**MAINE TURNPIKE AUTHORITY**

**ADDENDUM NO. 1**

**CONTRACT**  
**2021.02**

**WATER LINE AND UTILITY**  
**VAULTS**

UTILITY VAULT DETAILS  
STA. 2340+52.81 - DETAILS III

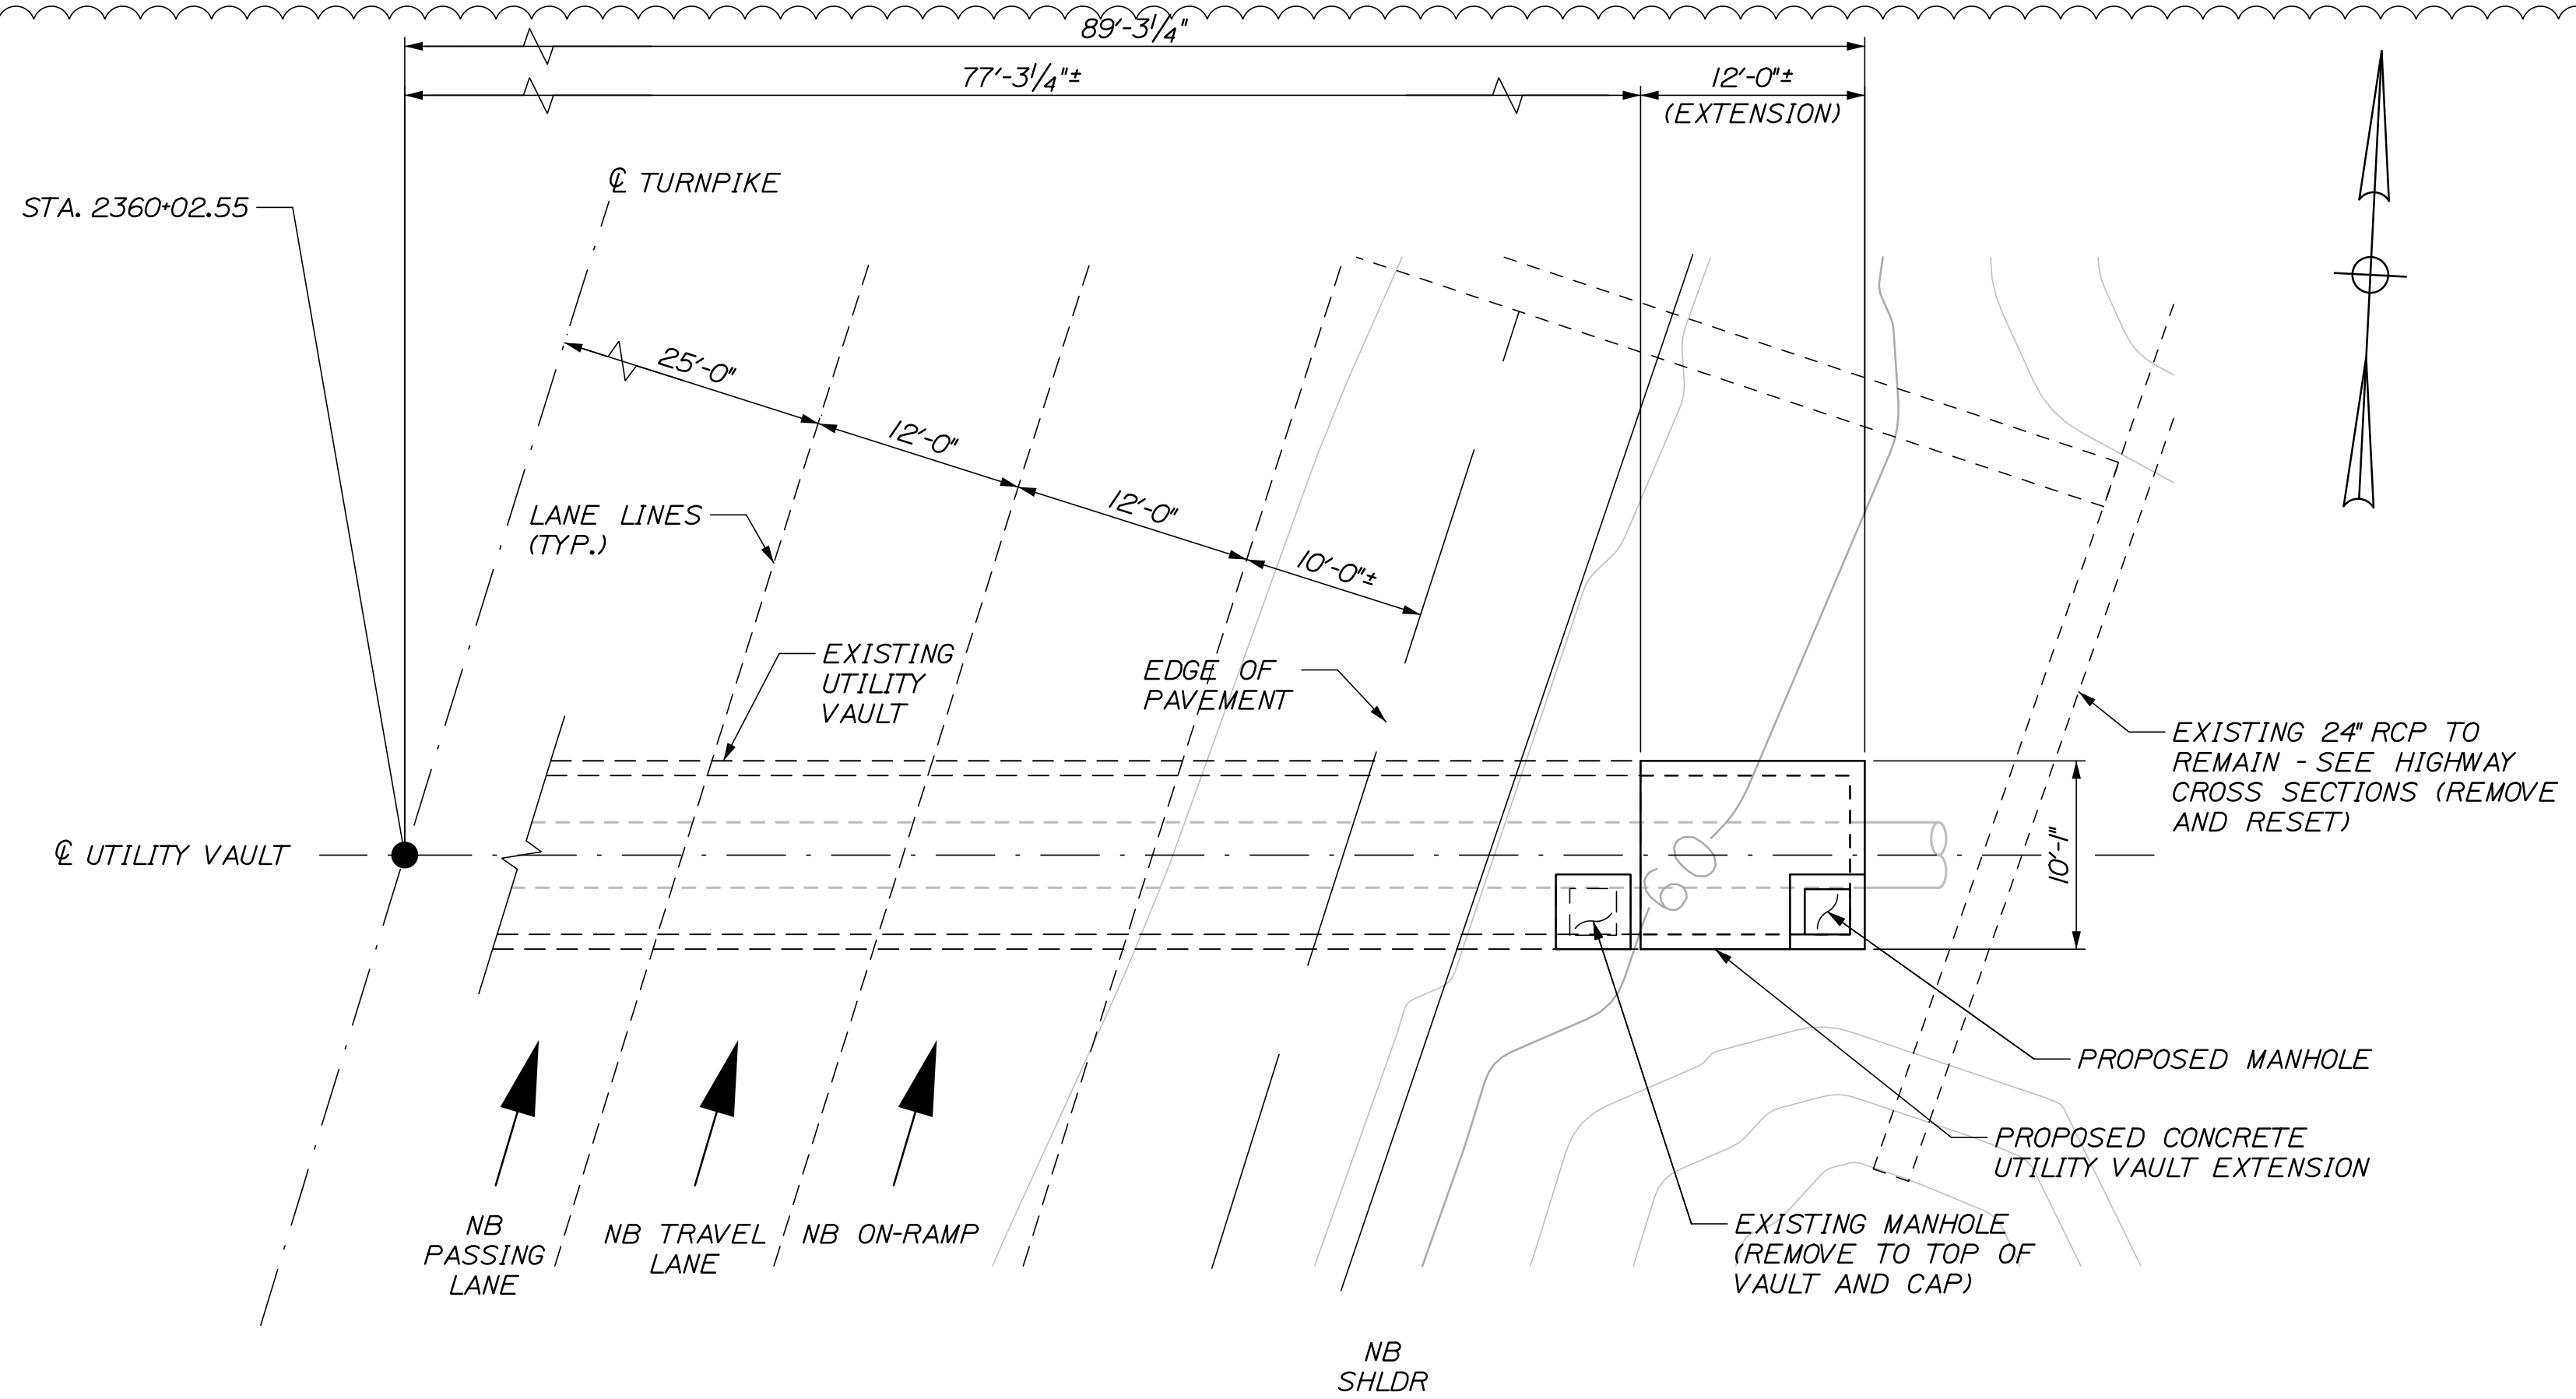
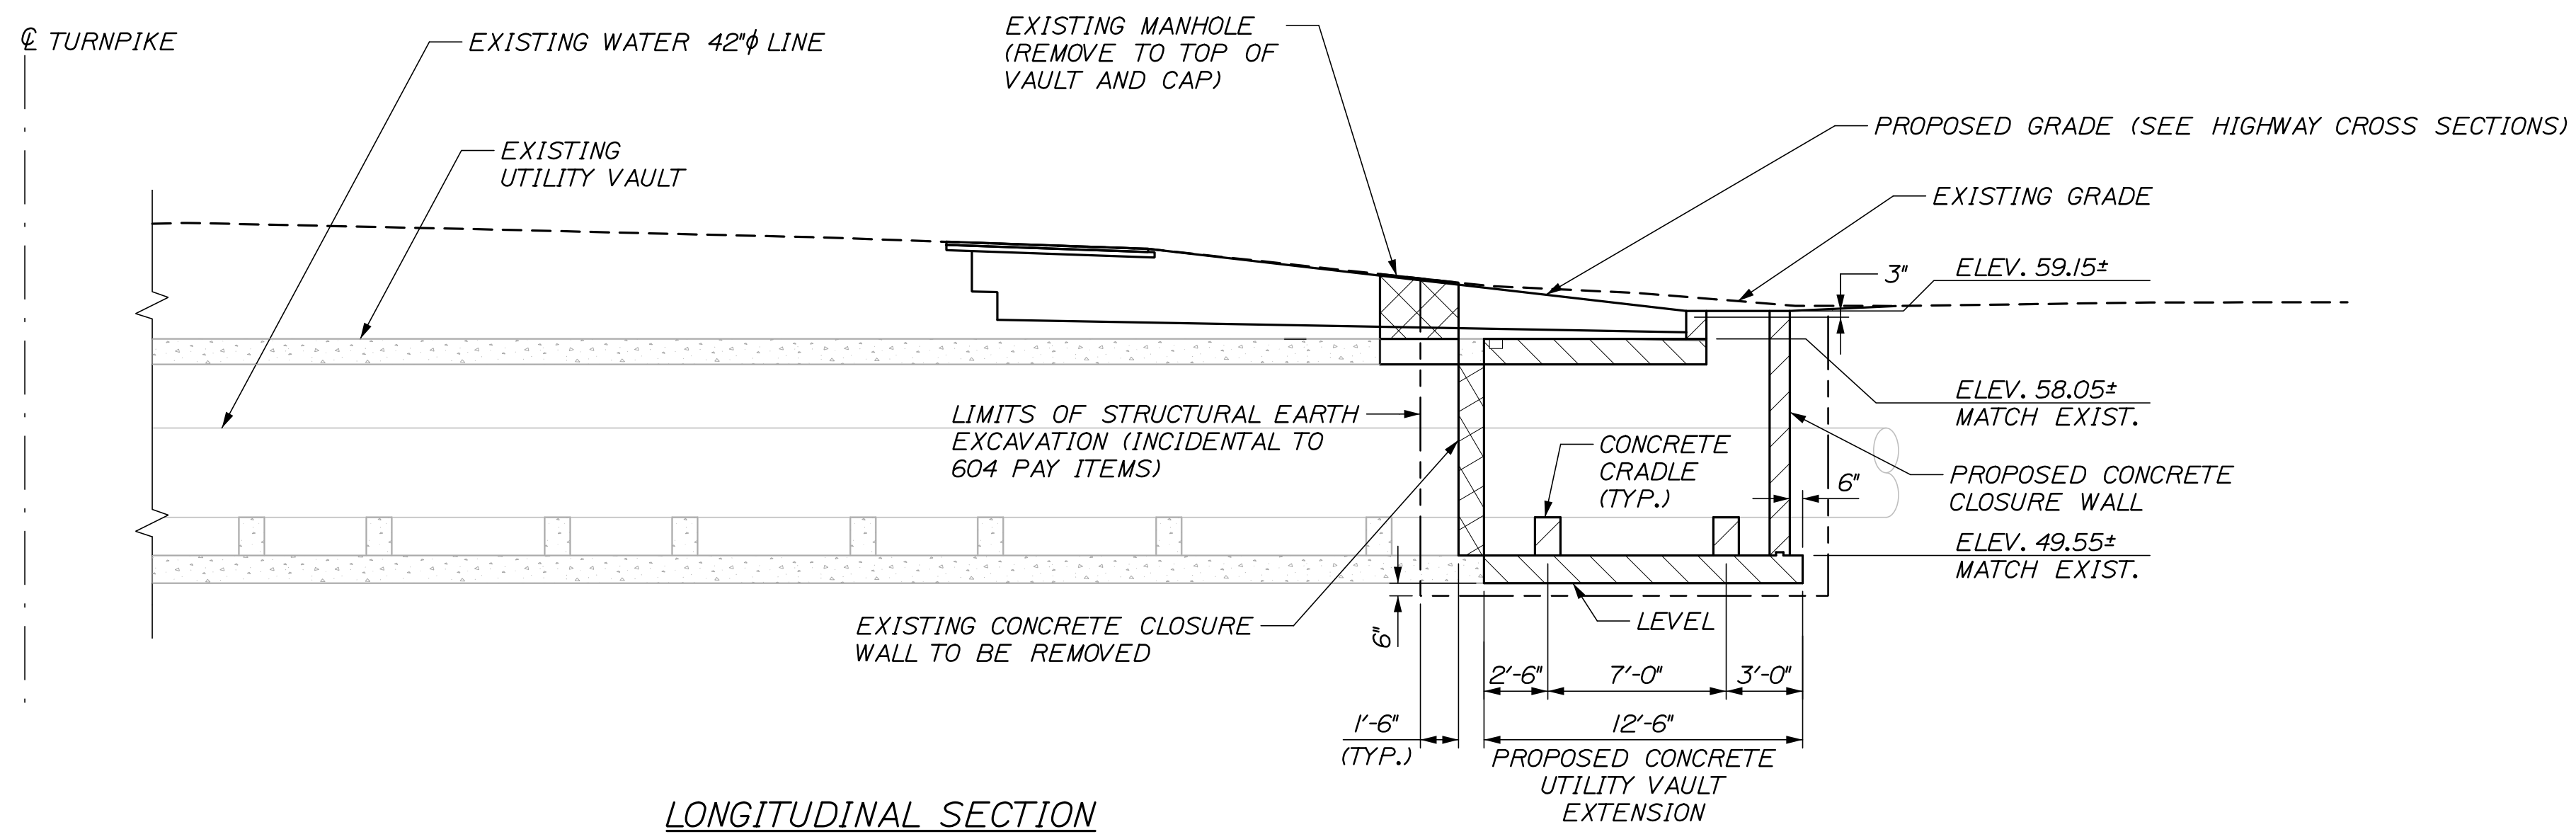
Scale:			
AS NOTED			
No.	Revision	By	Date
1	UPDATED EXIST. STRUCTURE LINEWORK	BRG	06/21
